E2228A-04

S E R V I C E N O T E

The E3858A Power Distribution Unit (PDU) used on the E2228A can affect system performance for certain measurements.

Figure 2. Removing Power Supply Cabling.

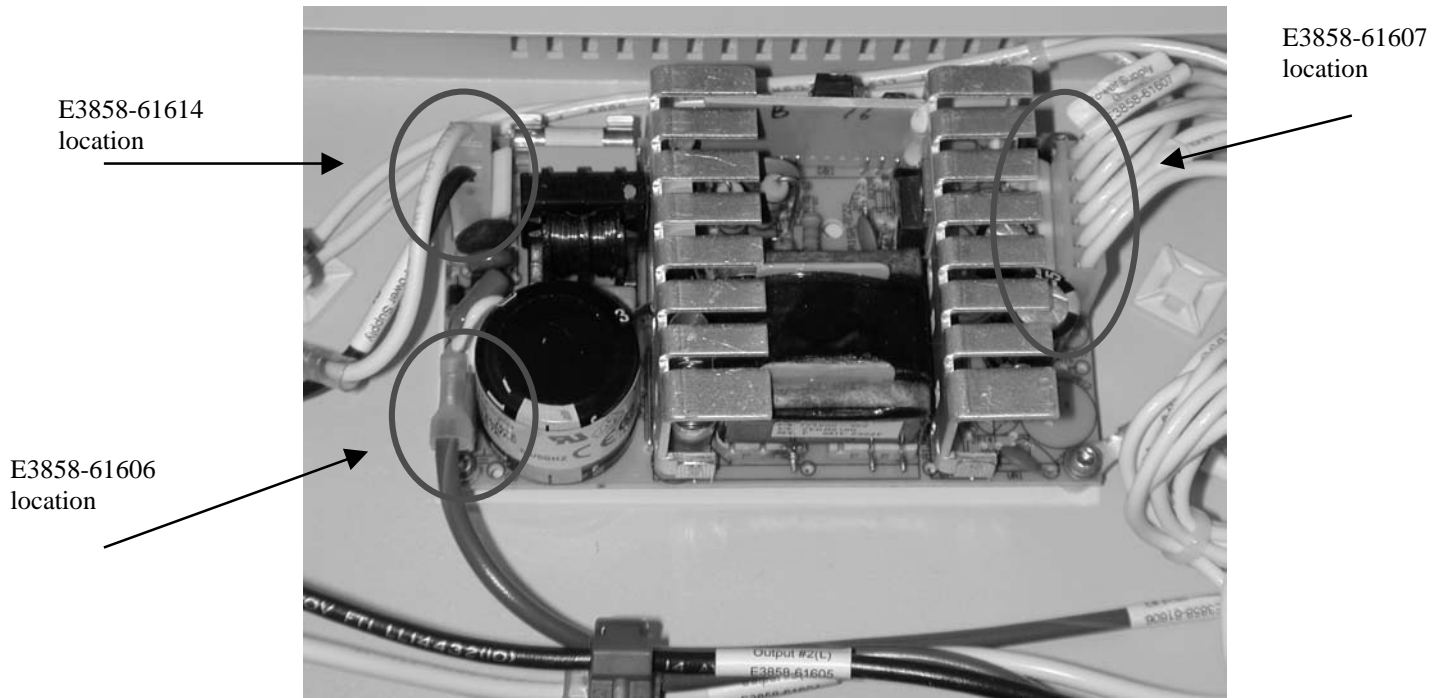
- Remove the connections to the PDU power supply as shown in Figure 2.
 - Use a flat-blade screw driver to help remove the white connectors
 - E3858-61614 (white and black cable into smaller white connector)
 - E3858-61607 (6 white wires into larger white connector)
 - Use a pair of pliers to pull out the connector with the green wire
 - E3858-61606 (green wire into connector)

Figure 4. ESD Protector with holes enlarged.

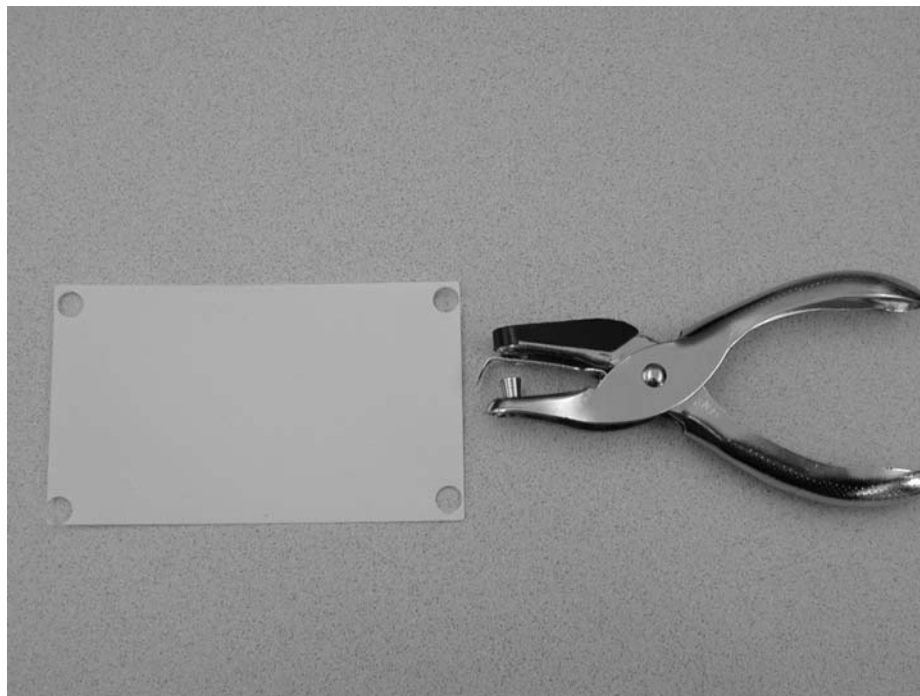
- Remove the white plastic ESD protector from the chassis.
- Enlarge the holes on the plastic protector using a hole punch (Figure 4).

Figure 5. Optional Modification to the ESD Protector.

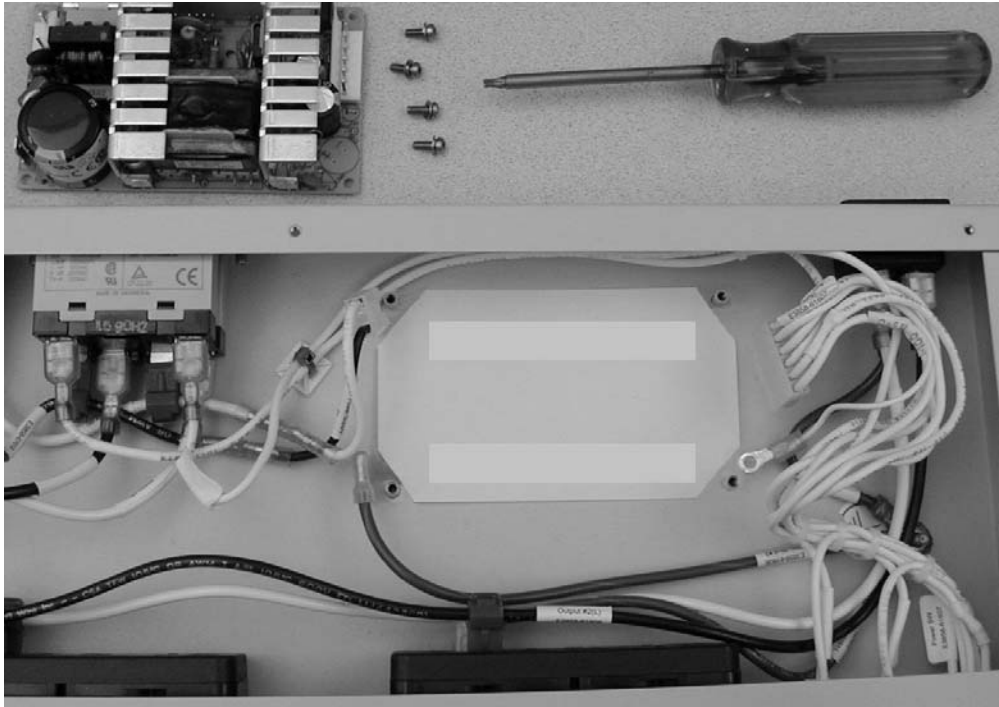
- Optionally, using a pair of scissors cut the corners of the plastic ESD protector as shown in Figure 5. Use two strips of double-sided tape to attach the ESD protector to the chassis.

Figure 6. Removing the wire from pin six.

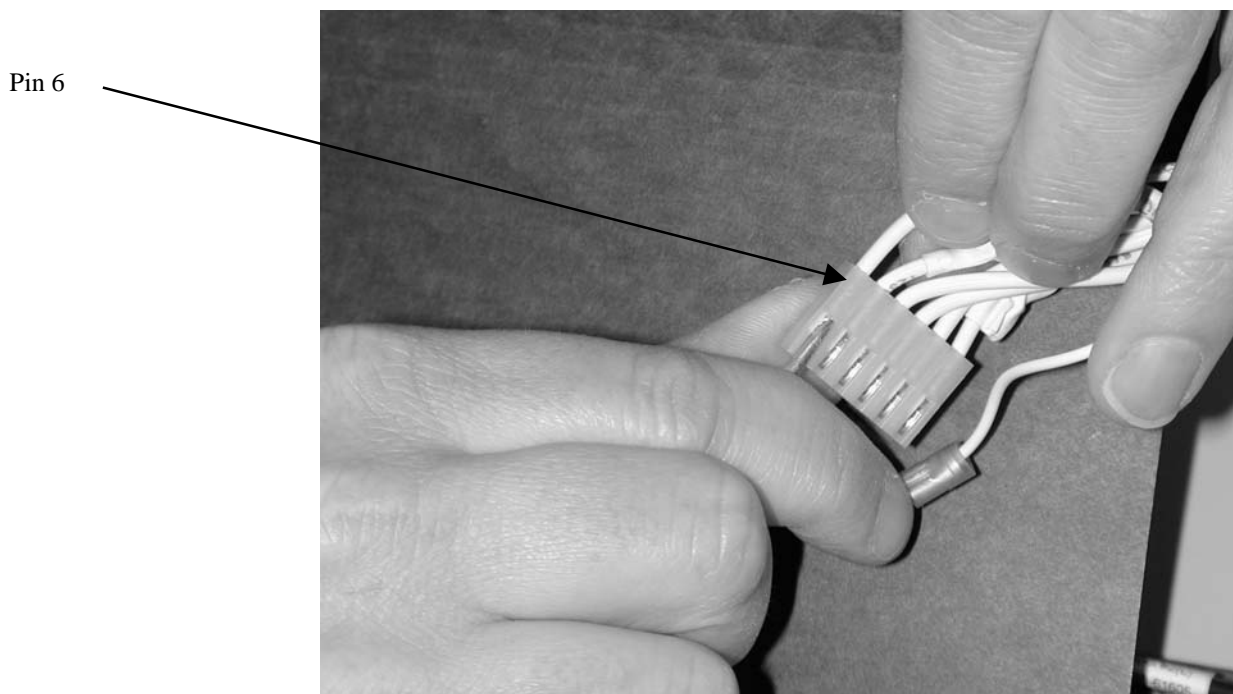
- Modify cable E3858-61607 as follows:
 - Remove the wire from pin 6 of the 6-pin connector. See Figure 6 for connector orientation to locate pin 6.

Figure 7. Adding a Wire With a Ring Connector to the Pin 6 (E3858-61607) Wire.

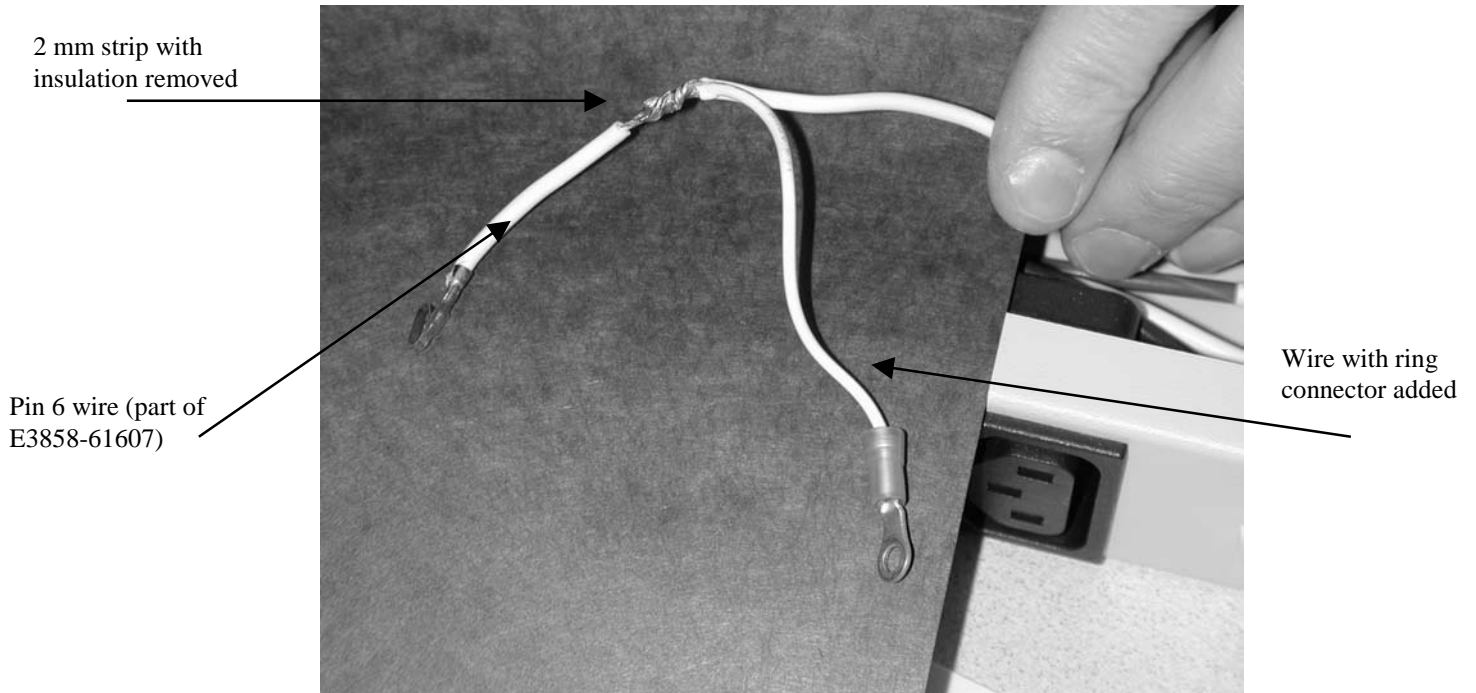
- Remove approximately 2 mm of insulation from the wire starting at 8 mm from the connector pin (Figure 7). Do not cut the wire.
- Using a piece of 20 AWG UL1061 wire 50mm long, remove approximately 8 mm of insulation from each end.
- Connect a ring terminal to one end of the wire. Solder the other end of the wire to the 2 mm strip of the pin 6 wire (part of E3858-61607). See Figure 7.

Figure 8. Heat shrink in place.

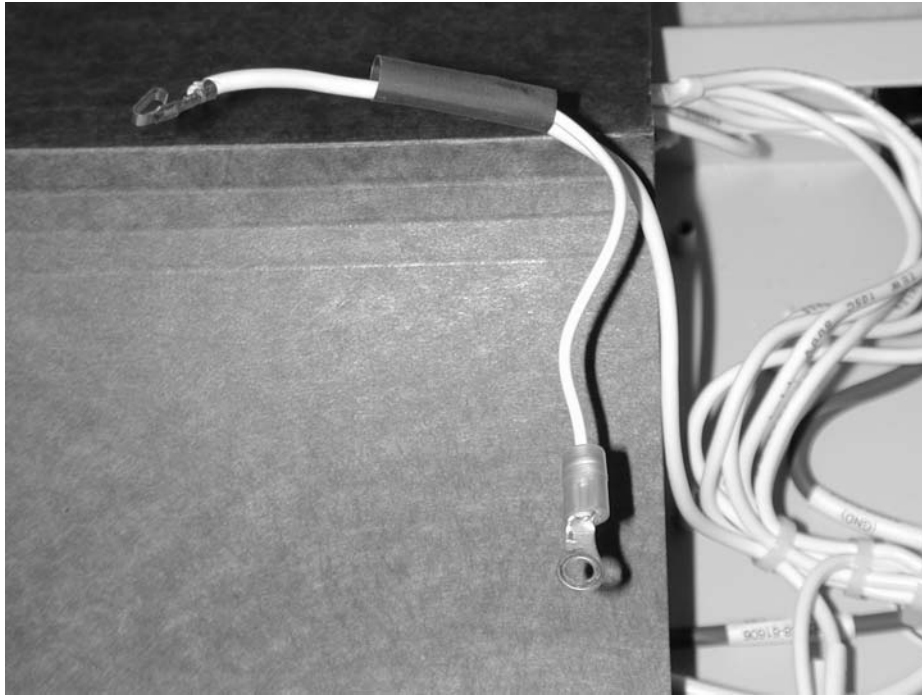
- Add a piece of heat shrink tubing (20mm long) over the soldered section (Figure 8). Use a heat gun to seal the heat shrink.

Figure 9. Remove Paint Residue from these Posts.

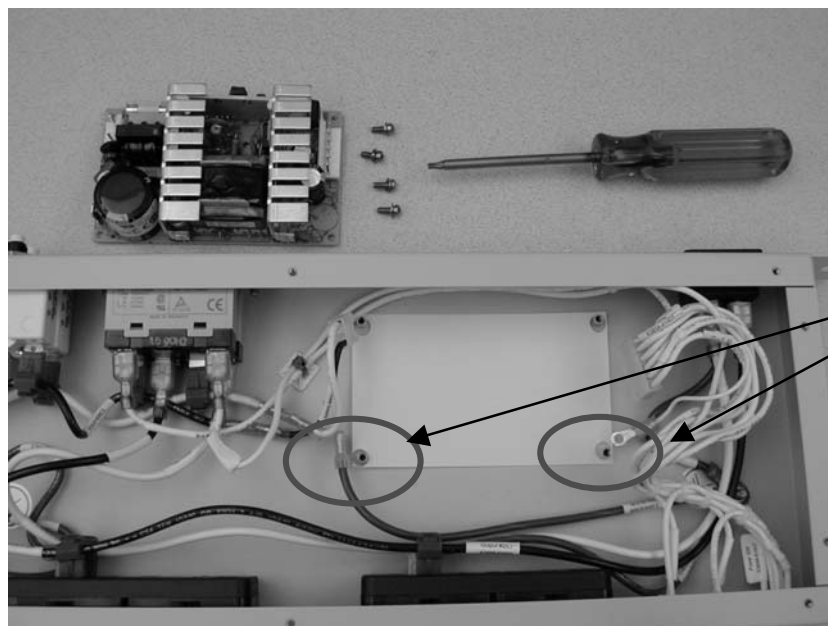
- Re-insert the pin into the 6-pin connector.
- Use a flat-blade screwdriver (or razor blade) to scrape any paint residue from the top of the posts indicated in Figure 9. This will ensure a good electrical contact between the PDU chassis and the power supply.
- Re-insert the plastic protector if a hole punch was used to enlarge the holes (Figure 4). The protector should now lay flat on the chassis base.

Figure 10. Re-installing the Power Supply and Connecting the Ground Wire to the Post.

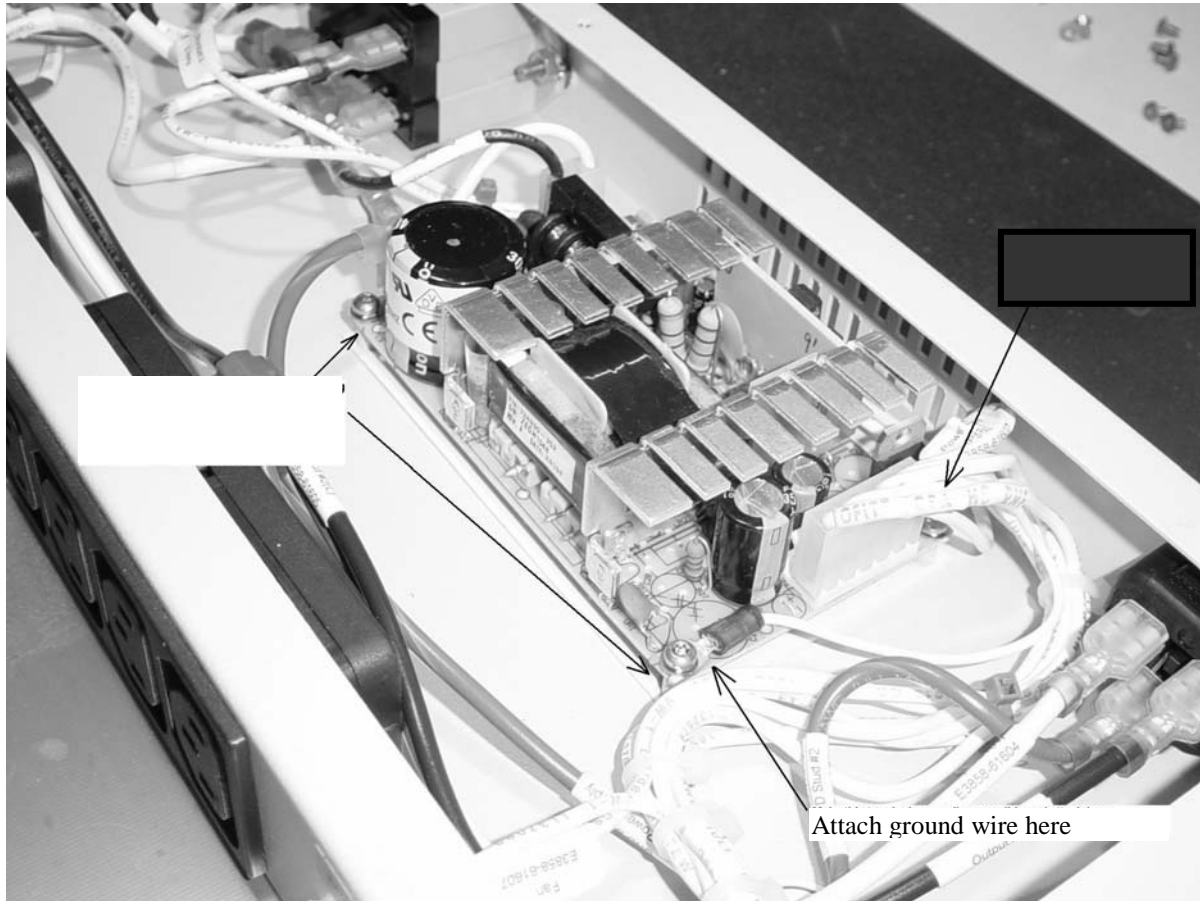
- Reinstall the power supply in the PDU chassis using the four screws. Attach the ground wire from the pin 6 wire to the post as shown in Figure 10. Reattach cables E3858-61614, E3858-61607, and E3858-61606 that were removed previously (Figure 2).

Figure 11. Measure Continuity Between these Points.

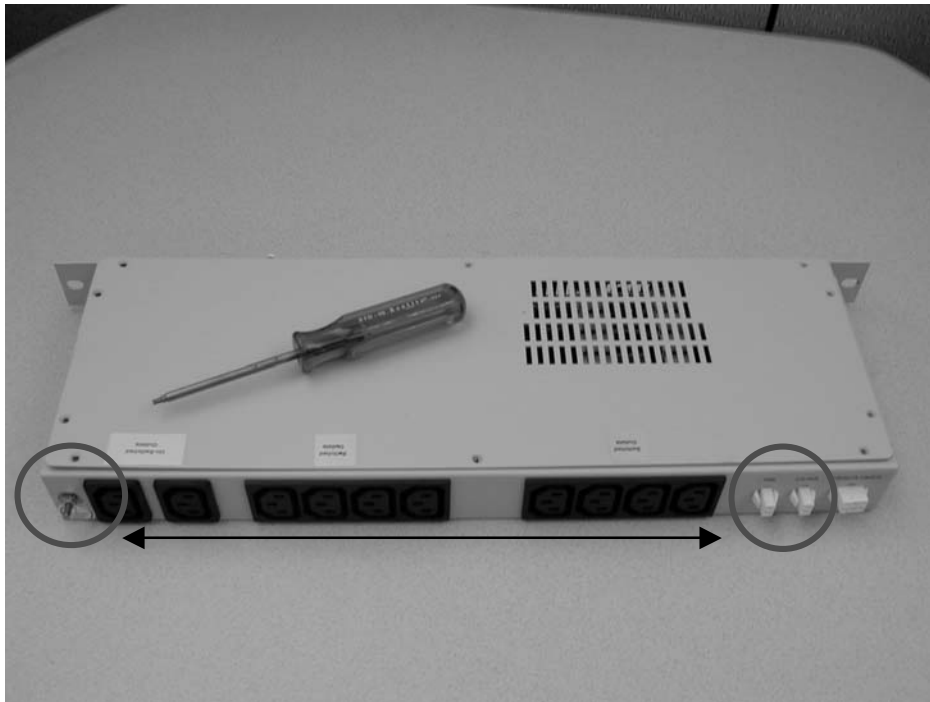
- Replace the PDU cover. Verify proper installation of the ground wire by checking continuity between the ground terminal and the bottom (LO) pins of the connectors shown in Figure 11. Re-install the unit in the system rack.
